COMMENTS OF ORMET CORPORATION ON THE PROPOSED REMEDIAL ACTION PLAN FOR THE ORMET CORPORATION SUPERFUND SITE JUNE 9, 1994

APPENDICES VOLUME III

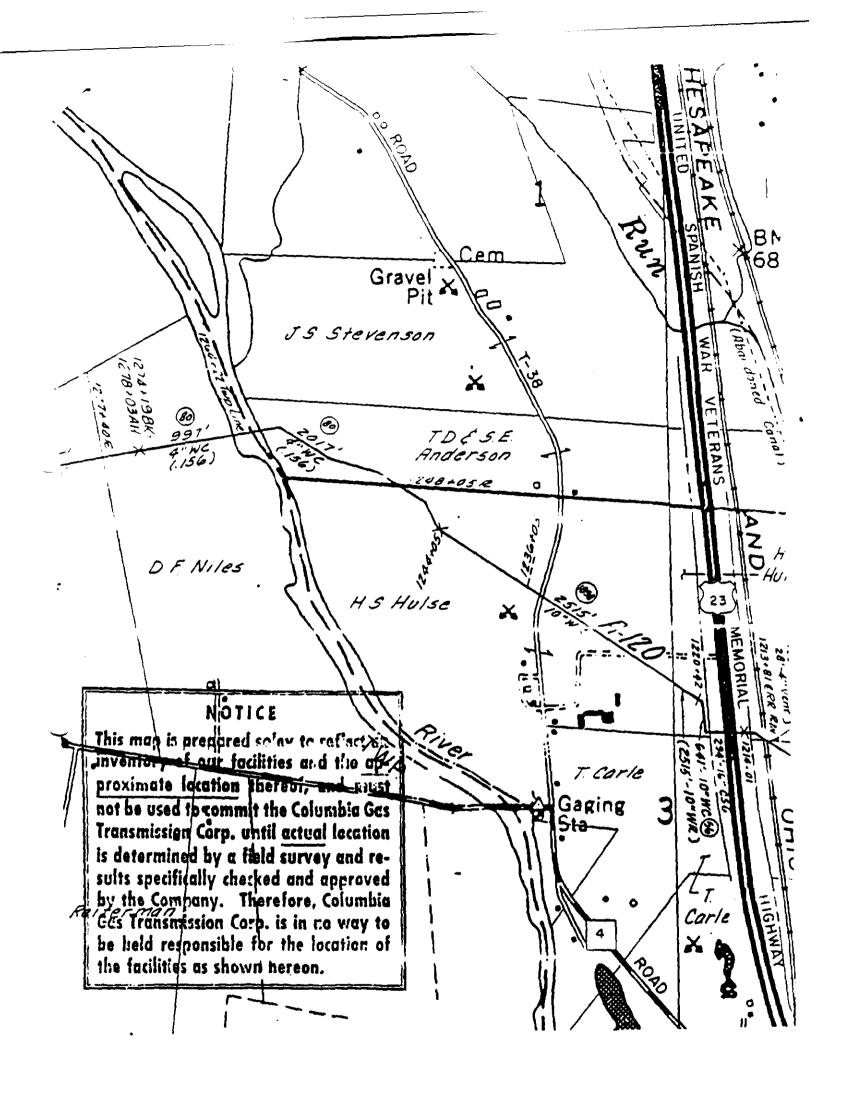
The proposed plan fails to address the fact that a large diameter natural gas transmission line crosses the northeast corner of the site. This line is owned by Columbia Gas Transmission Corp. and is designated as Line A-120. A map indicating the location of this line is attached hereto.
